**Appendix V of RNTPC
Paper No. Y/I-DB/2C**

Section 12A Application No.Y/I-DB/2

For rezoning the permissible use from staff quarters to permit flats at Area 6f, Discovery Bay Response to Comments

Applicant's response to the departmental comments made available by District Planning Office on 23 and 28 December 2016 and 17 January 2017

Figure 1 Sewage Treatment Technology in Hong Kong

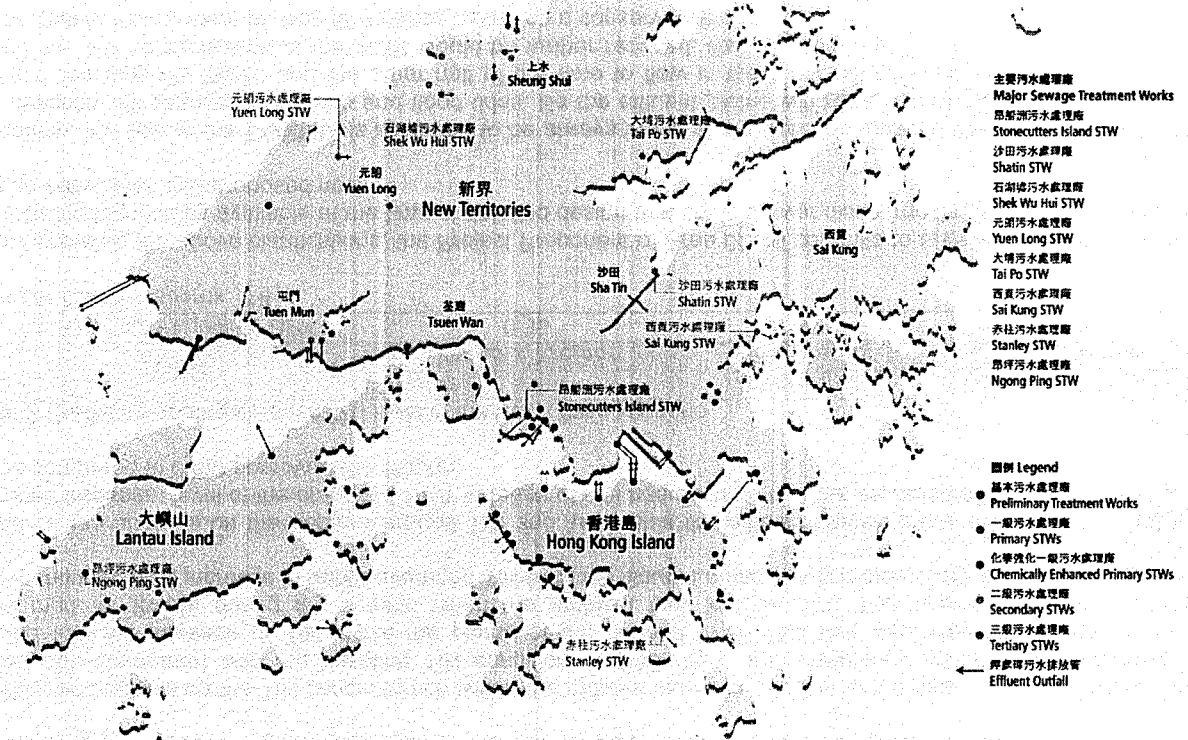
14. Please supplement the effect of sedimentation on the water sensitive receivers as a result of STW operation in the report.	As regards the sedimentation, since the plume according to the model is above the seabed according to Section 5.1.1.2 of the previously submitted technical note, there would be no direct deposit of suspended solid to the bottom. Even if it is assumed that the plume can hit the seabed and other conditions remain unchanged, the increase in the concentration of suspended solid would be <0.1 mg/L (=30/209, Table 5.2 of the technical note) which is within the natural fluctuation of the annual concentration of suspended solid. It is thus anticipated that the sedimentation due to the treated effluent would be insignificant.																								
15.S.5.1.1.6 - The assessment results indicated that the increase in TIN level at the water surface (i.e. inside the sewage plume) could be up to 27% as compared with baseline level. If this is the case, such increase may have significant impact to the nearby bathing beach (i.e. WSR 04) such as red tides occurrence. The applicant should exhaustively explore and provide all practicable mitigation measures to minimize the residual impact from the proposed STW (e.g. adoption of more advanced treatment technology, review the discharge location, etc.) and update the assessment findings. It is noted that the conclusion was also mentioned in S.7 of the ecological section, AFCD's comment should also be sought.	<p>Sewage Treatment Level of Planned and Existing Sewage Treatment Works on South Lantau</p> <p>The proposed STW for Area 6f has a capacity of 440 m³/day and will adopt the MBR technology to treat the sewage generated by the planned population in Area 6f to appropriate level before discharge. Table 1 compares the flow rates and discharge limits for the key pollutants from the proposed STW and the STW as adopted in Outlying Islands Sewerage Stage 2 – South Lantau Sewerage Works (South Lantau EIA) which also involves a new STW discharging into the water of South Lantau.</p> <p>It can be seen from Table 1 below that the proposed STW has adopted the same treatment technology as the South Lantau STW (SLSTW). Although the flow rate for the proposed STW is much lower than that in the SLSTW, the concentration of <i>E. coli</i> has been purposefully reduced to 10 counts/100ml which is significantly lower than that of 1,000 counts/100ml in the SLSTW. In fact, the proposed discharge limit of 10 counts/100mL is even lower than the WQO and hence any risk of human contact has been proactively addressed. In terms of TIN, it can also be noted that the discharge from the proposed STW would reach a concentration of 20mg/L which is also lower than the 30 mg/L as adopted in the SLSTW. It can therefore be seen that the discharge limit in the proposed STW for Area 6f is by all aspects much better than that adopted in the SLSTW which is also discharging into the sea area off South Lantau.</p> <p>Table 1 Comparison of Effluent Discharge Standards against South Lantau EIA</p>

The proposed STW at Area 6f having adopted the above treatment technology, its MBR technology is also comparable to the existing sewage treatment technology adopted on South Lantau and its surrounding outlying islands. The MBR technology is composed of activated sludge treatment and microfiltration/ultrafiltration which can be classified as secondary treatment level. As shown in **Figure 1** below, the majority of the existing STWs on South Lantau and its surrounding outlying islands are implementing secondary treatment level. Therefore, the adopted MBR is also consistent with the existing sewage treatment technology in South Lantau.

Job Title			DISCOVERY BAY - OPTIMIZATION OF LAND USE		ATTACHMENT 2	
Date	Scale	Drawing Title				
JAN 17	AS SHOWN	EXISTING AND PROPOSED SEWERAGE LAYOUT PLAN				
Drawn	Job No.					
GL	235928	ARUP

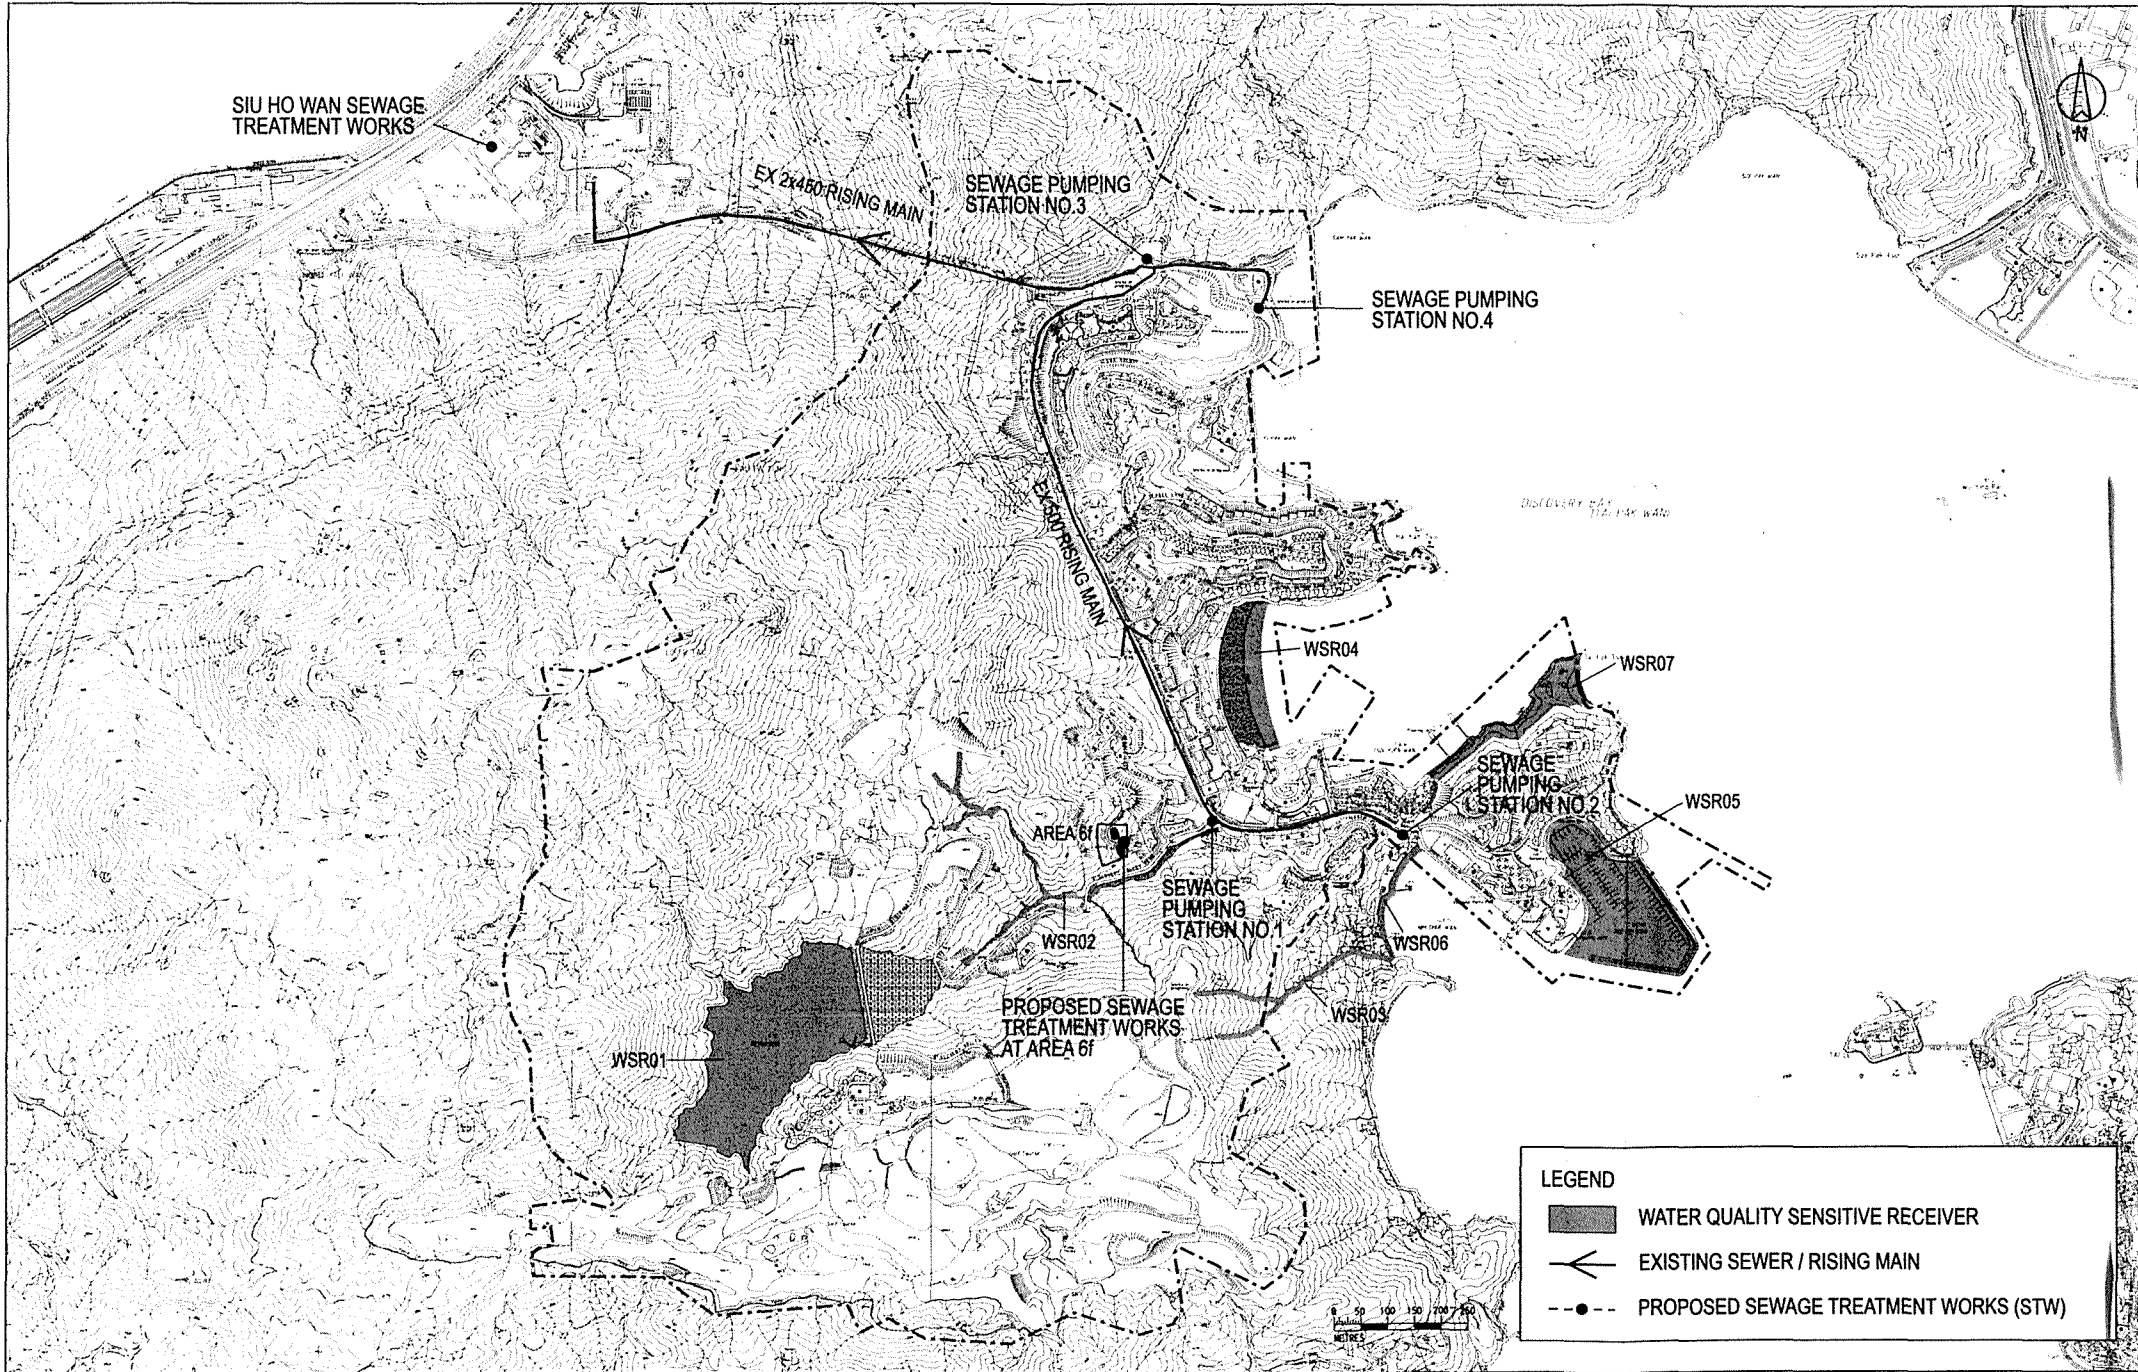
10.S.6.3.2.1 - For the proposed contingency measures of the STW, the Applicant proposed to provide emergency overflow pipe from the STW to divert the raw sewage to the existing Sewage Pumping Station no. 1 then to SHWSTW for treatment. DSD's comments on its technical feasibility should be sought and consent should be obtained from the Authority for accepting the additional sewage from the proposed development during emergency. Please indicate the location of SPS no. 1 and identify the water sensitive receivers nearby. Please also advise any measures to avoid the impact of emergency discharge due to pipe bursting.	<p>The planning application with all the technical reports has already been circulated to DSD, and no adverse comments were received.</p> <p>Please refer to Attachment 2 for the locations of SPS No. 1, 2 and 3. All three SPSs have the same design capacity that they all have 2 duty pumps and 1 standby pump with a duty capacity of 32,832 m³/day and a standby capacity of 16,416 m³/day respectively. Sewage received by SPS No.2 (most upstream) is conveyed to SPS No.1 and eventually enters SPS No.3 (most downstream), which then transfer flow to Siu Ho Wan STW. As the maximum existing flow for SPS No.3 is estimated to be around 27,750 m³/day (i.e. 25,000 planned max. residential population + 15% for commercial activities), which is within the capacity of the duty pumps (i.e. 32,832 m³/day). Hence, SPS No.1 and No.2 would have enough capacity for the emergency use as the existing flows are less than that in SPS No.3 because SPS No. 1 and No. 2 are upstream of SPS No. 3. The proposed emergency overflow sewers between the proposed STW at Area 6f and the SPS No. 1 will be gravity sewers mainly along the relatively steep Discovery Valley Road so there is no risk of pipe bursting as no pressurize sewage rising main is proposed for the emergency overflow sewer.</p> <p>In addition, in order to demonstrate the capacity of each SPS during emergency situation, the table below summarises the capacity of SPS No. 1, 2 and 3.</p>

18. Rtc - The Siu Ho Wan STW has no spare capacity to cater for sewage arising from the proposed developments in Discovery Bay. The applicant should clearly indicate that the developer shall make own provision to treat the sewage to arise from the development.	The additional 440m ³ /day sewage generated by the proposed residential developed would be catered by an onsite sewage treatment facility which would be implemented by the Project Proponent. Yet in view of the fact that there are various on-going new developments at North Lantau and Airport, expansion of the Siu Ho Wan sewerage treatment facilities in order to provide extra sewage treatment capacity is likely to take place. The Project Proponent believes that, should EPD plan for infrastructure expansion, all proposed future developments in the vicinity areas, including those in the Discovery Bay, should be considered on equal and fair basis. In addition, the proposal for Area 6f is moderate in scale, the demand on the overall Government infrastructure would be insignificant. Therefore, the Project Proponent requests EPD to take into account the proposed development should they consider for future expansion of the Siu Ho Wan facilities.
